# HISTORIC AND DESIGN REVIEW COMMISSION

**HDRC CASE NO:** 2017-278  
**ADDRESS:** 701 EVERGREEN CT  
**LEGAL DESCRIPTION:** NCB 399 BLK 27 LOT 12A  
**ZONING:** R-6 H  
**CITY COUNCIL DIST.:** 1  
**DISTRICT:** Tobin Hill Historic District  
**APPLICANT:** Geoffrey Myane  
**OWNER:** Geoffrey Myane  
**TYPE OF WORK:** Demolition of rear accessory structure, exterior modifications, construction of 1-story rear addition

## REQUEST:

**REMODEL FRONT EXTERIOR ELEVATION**

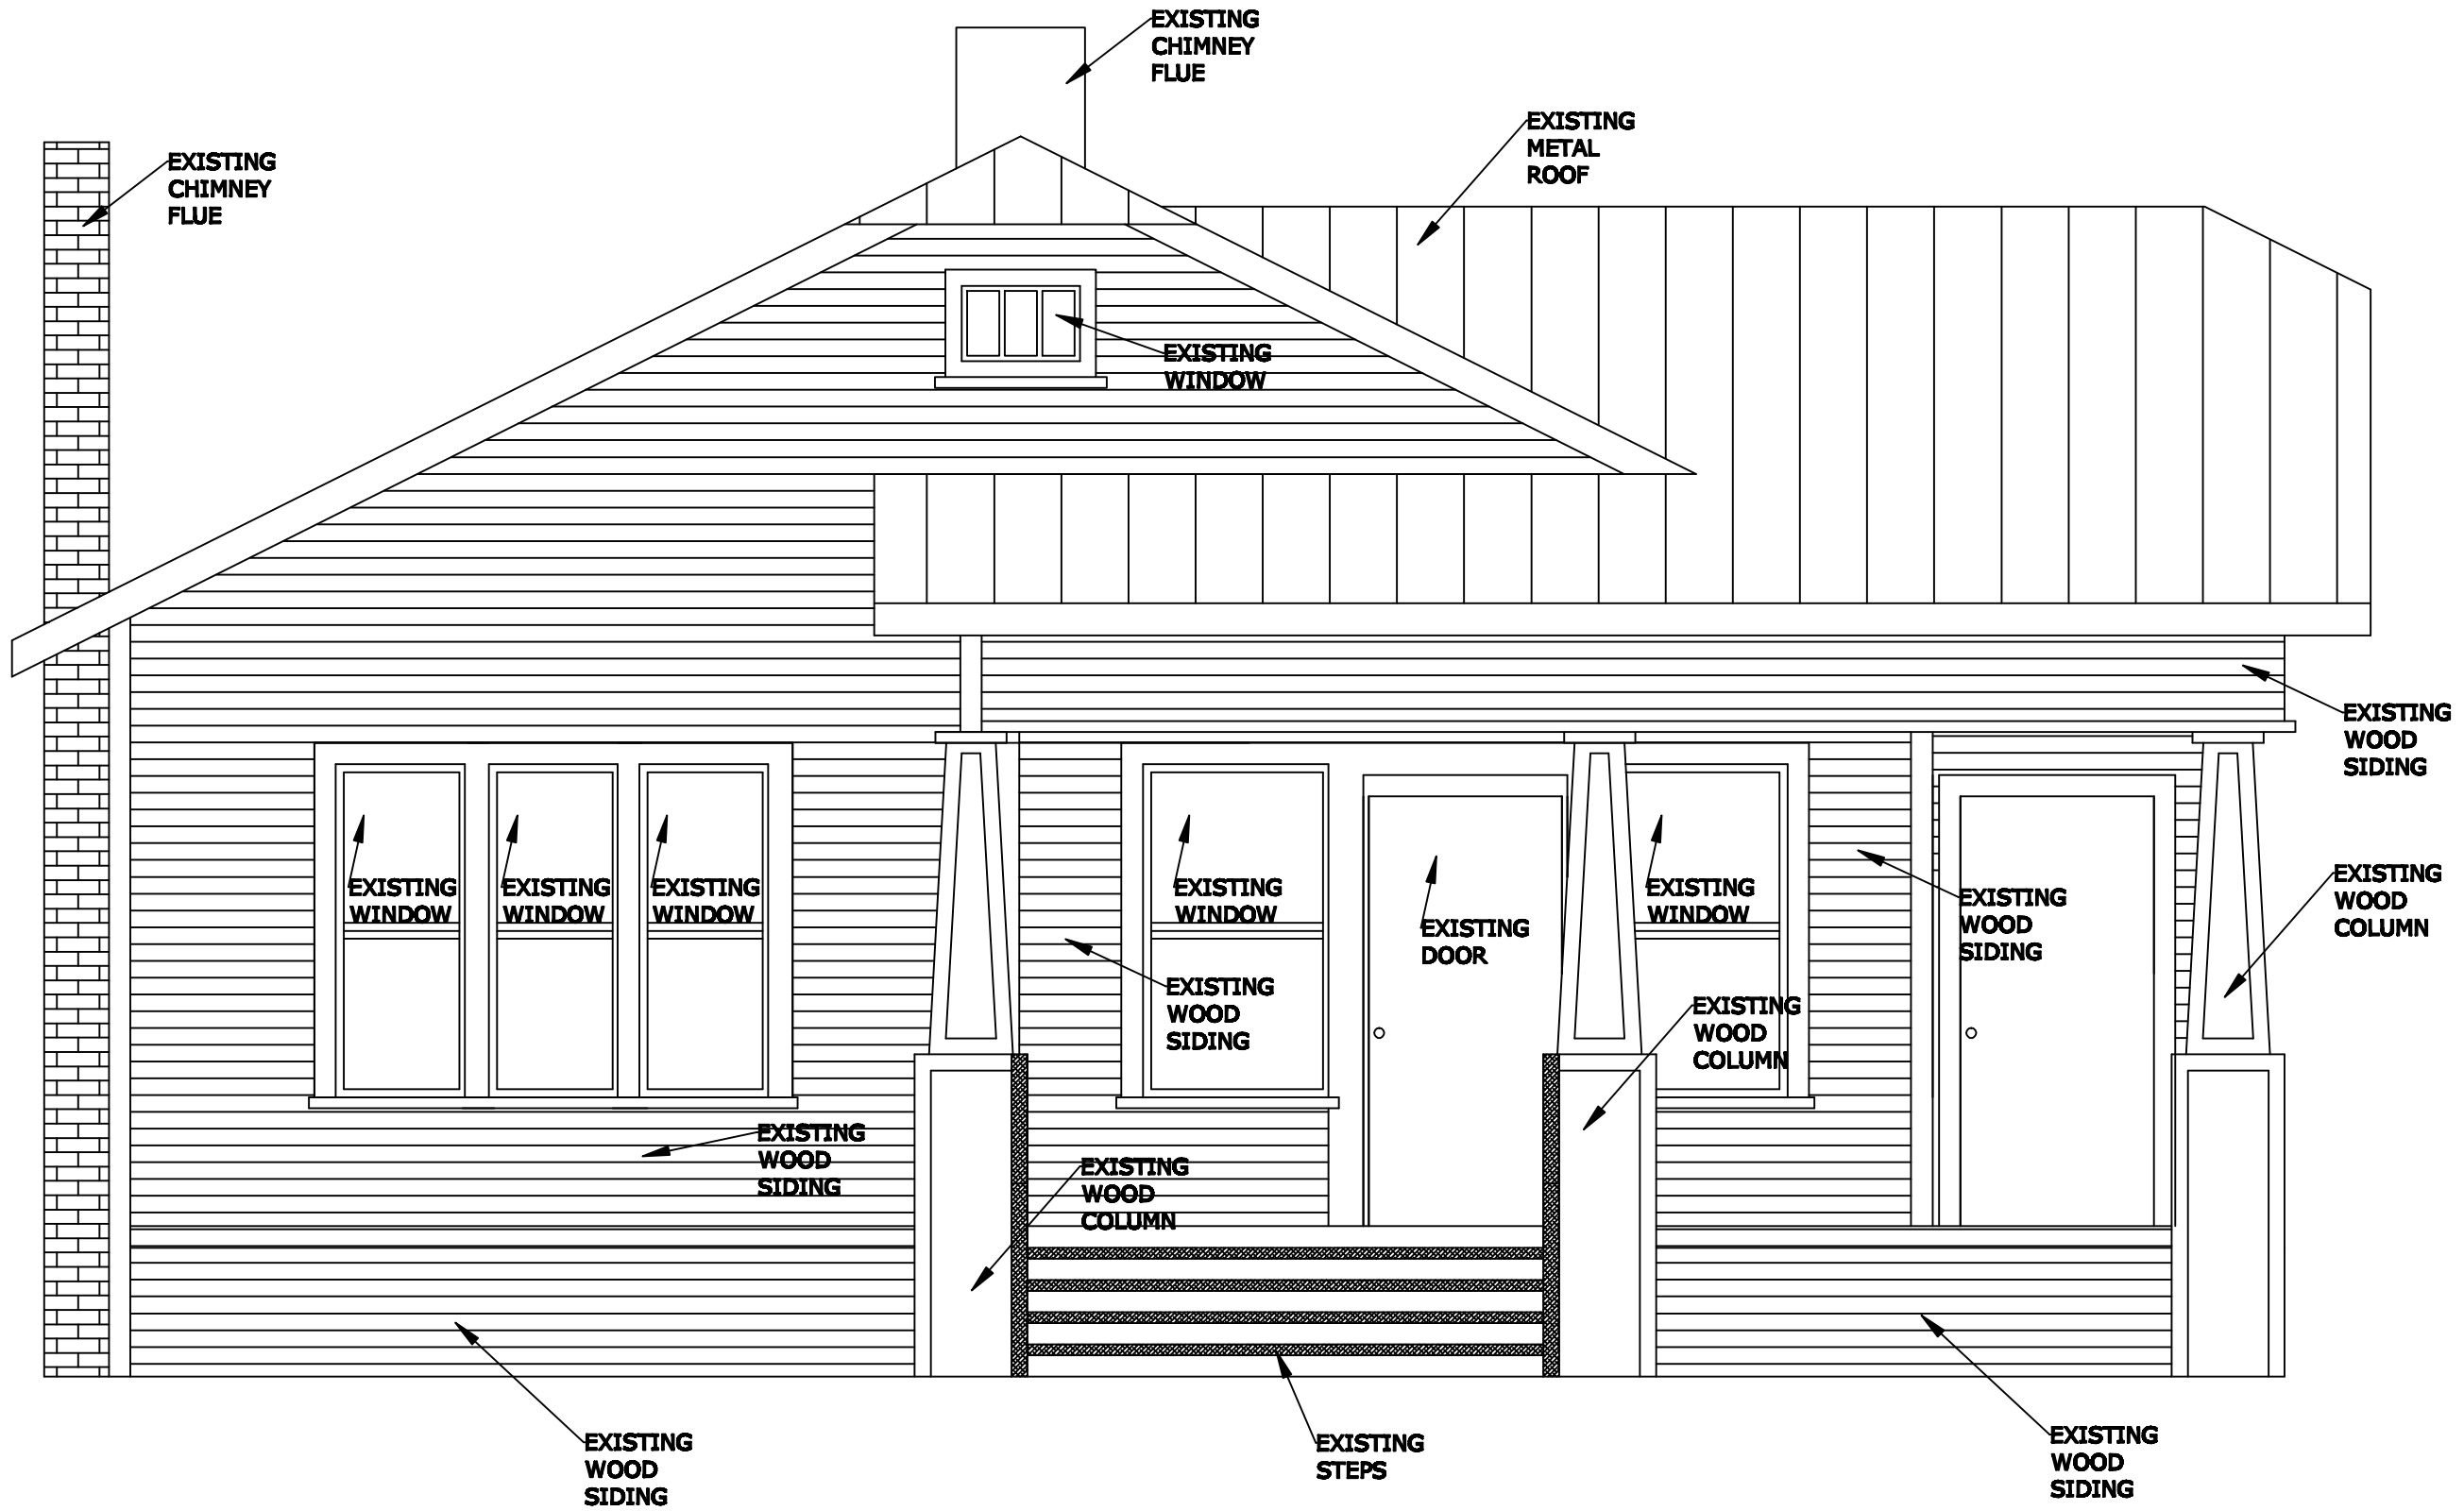
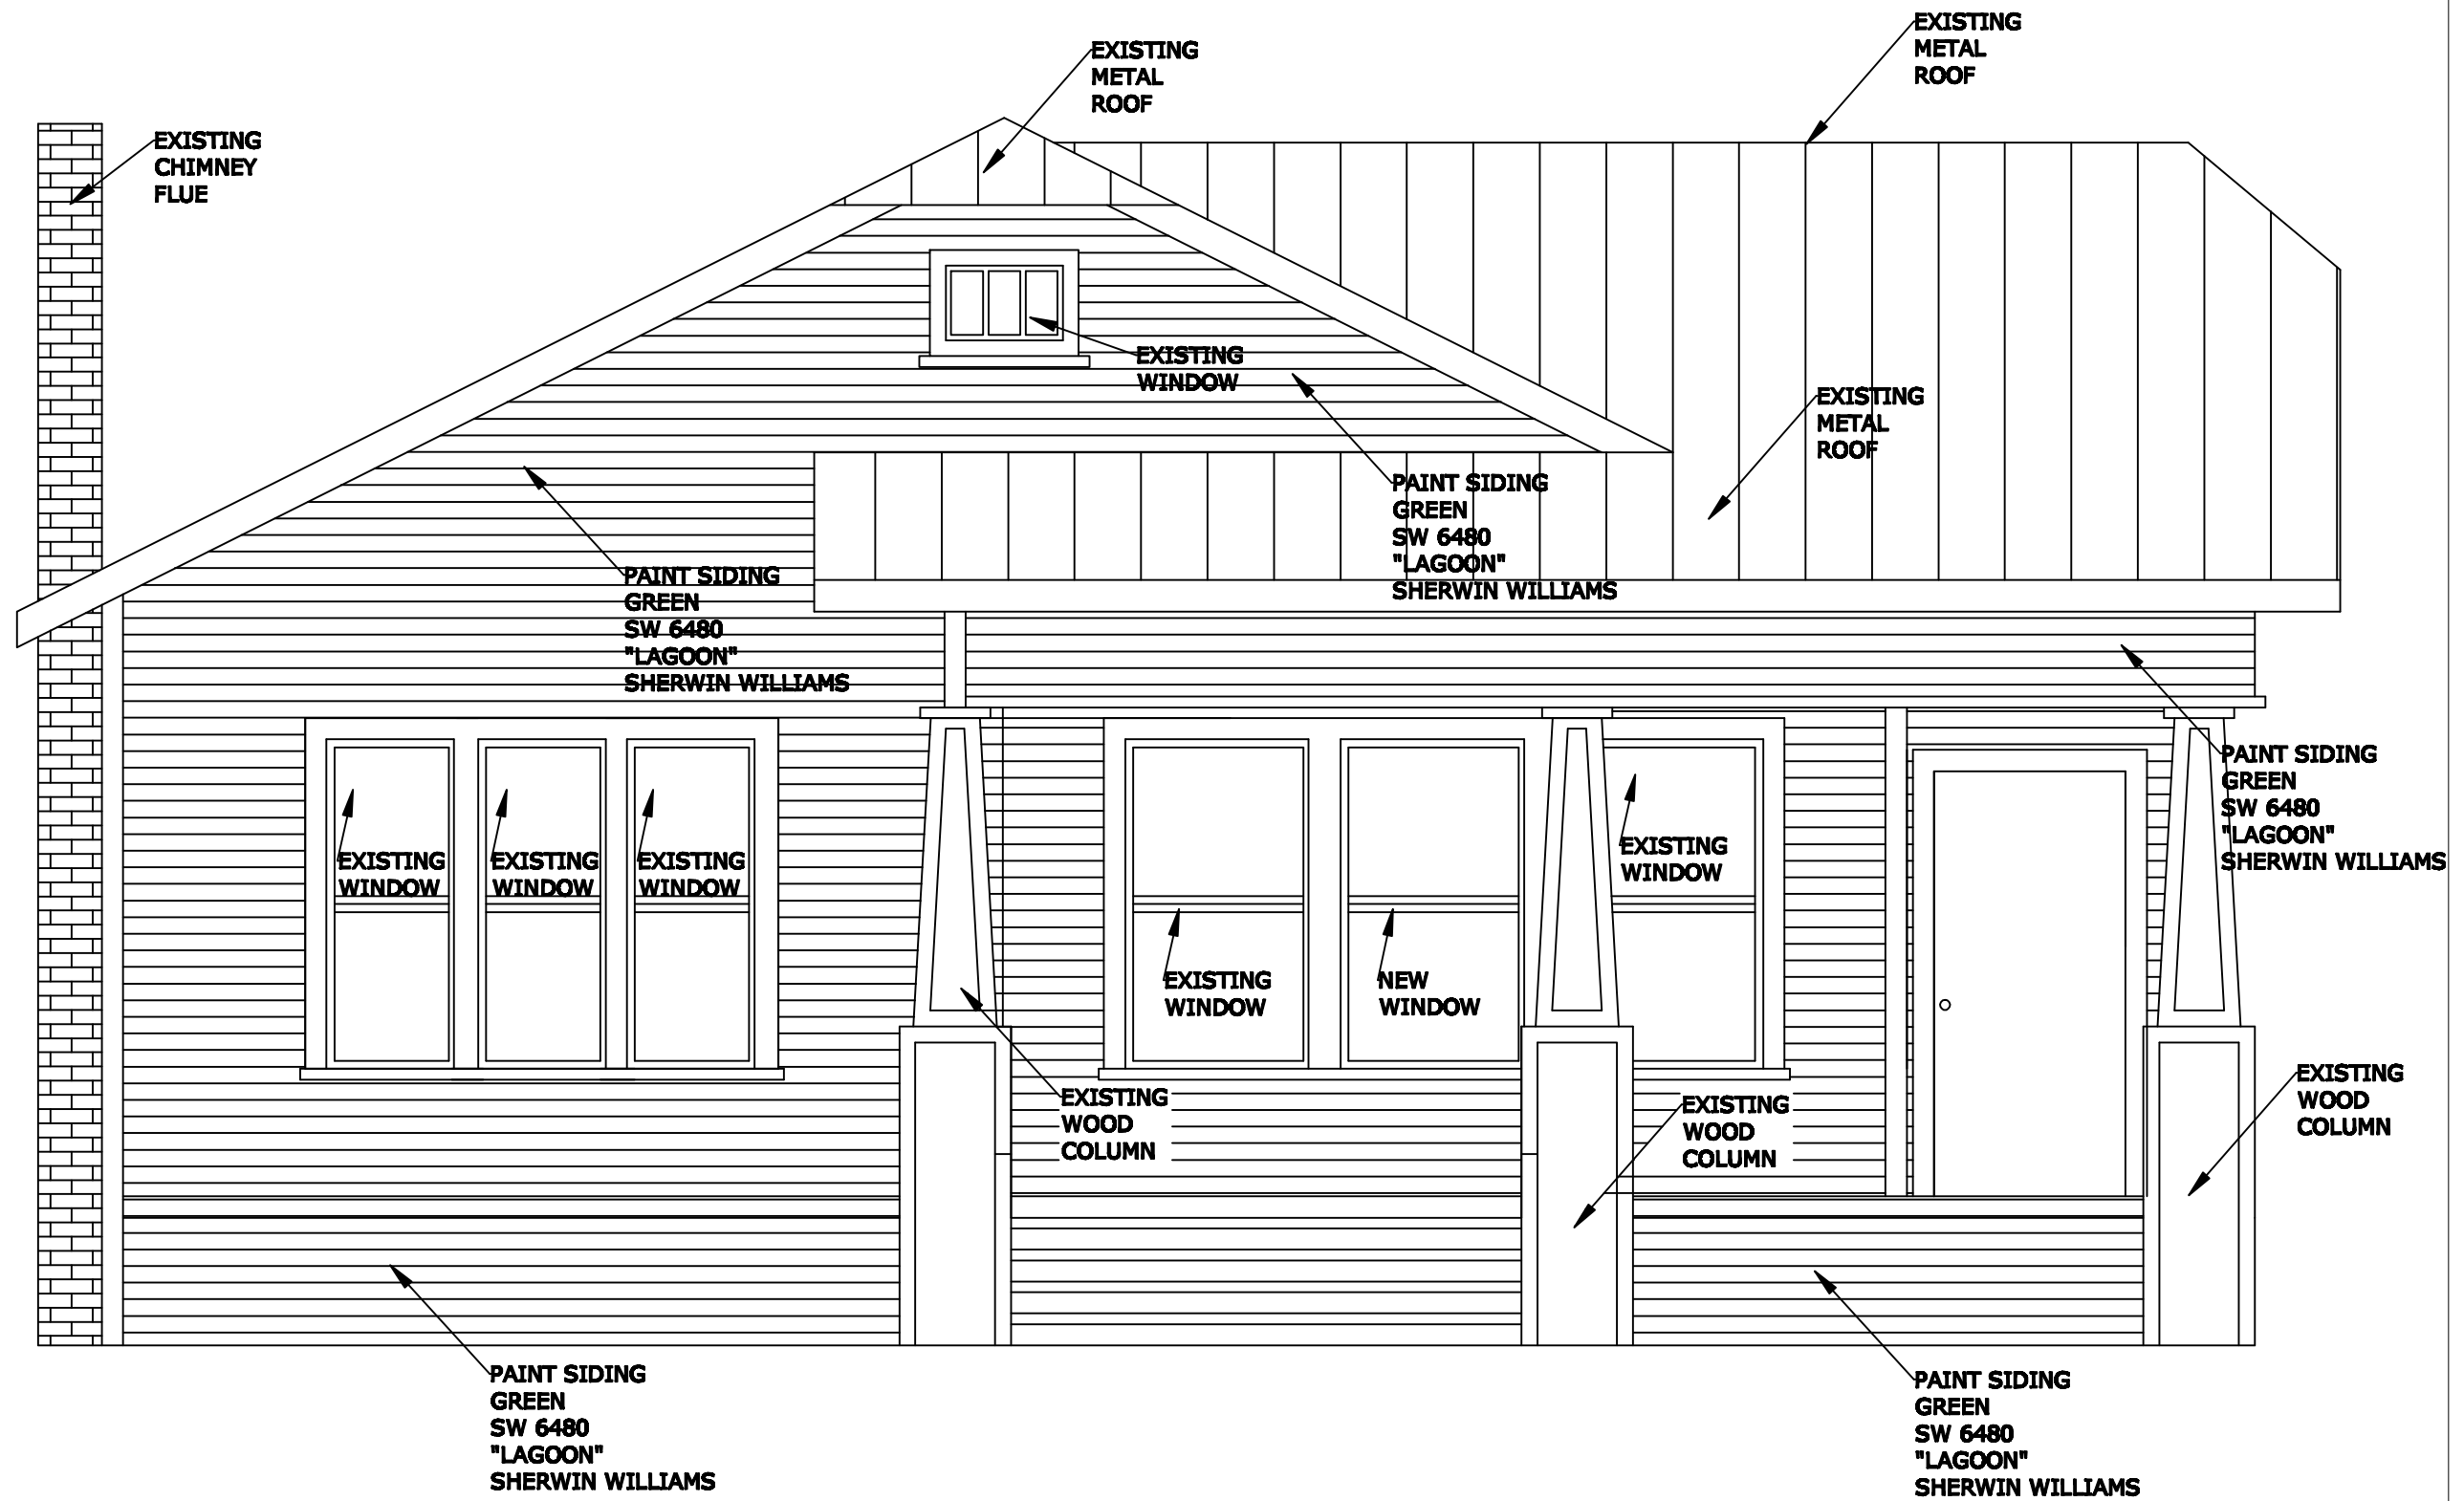
- FRONT DOOR REMOVAL** – The applicant has proposed to enclose one of two existing front doors with siding to match the material and profile of existing. According to Guideline 6.A.i for Exterior Maintenance and Alterations, historic openings should be preserved. Staff finds the proposal inconsistent with the guidelines.

- Item 1, Staff does not recommend approval of the demolition of the rear accessory structure based on findings a and b.
- Item 2, Staff does not recommend approval of the front door removal based on findings a and c.
